# SERVICE BULLETIN

Service Bulletin No.: DA20-79-02, Rev. 1

Title: Winterization Kit

Figure 1. Oil Cooler Baffle Installation

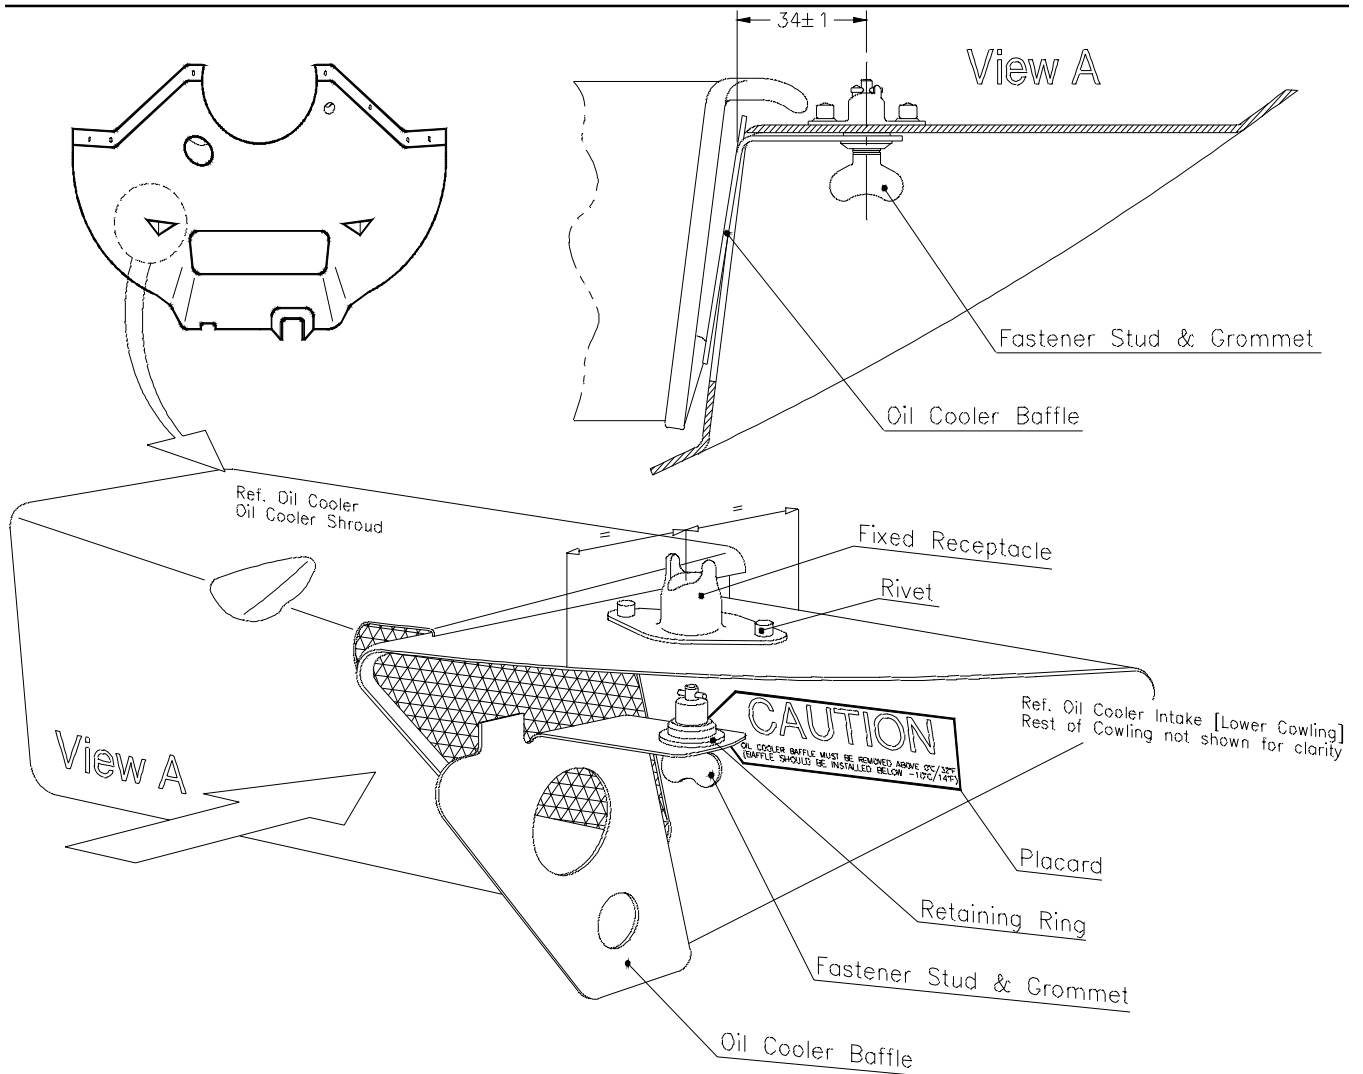
- 10.1 Place oil cooler baffle (ref. pn. 20-7910-03-01, supplied) in required position as shown in figure 1. Mark fastener pilot hole using oil cooler baffle as template. If required, grind flat upper lip of the oil cooler inlet so the baffle sits flat against the upper surface of the oil cooler air intake.

- 10.2 Remove lower engine cowling in accordance with chapter 71-10 of the Aircraft Maintenance Manual and drill 1/8" pilot hole through the cowling .
- 10.3 Enlarge pilot hole to 5/8" (15mm) diameter. Orient receptacle so the rivet holes are in line with oncoming air flow (ref. view A, figure 1) and use it as template for drilling two 1/8" rivet holes in the engine cowling.

- 10.4 Install receptacle 214-16 (supplied) with two rivets (ref. CCR244SS4-04, supplied) to the lower engine cowling as shown on figure 1.
- 10.5 Apply caution placard (supplied) to the engine lower cowling at location shown in figure 1.
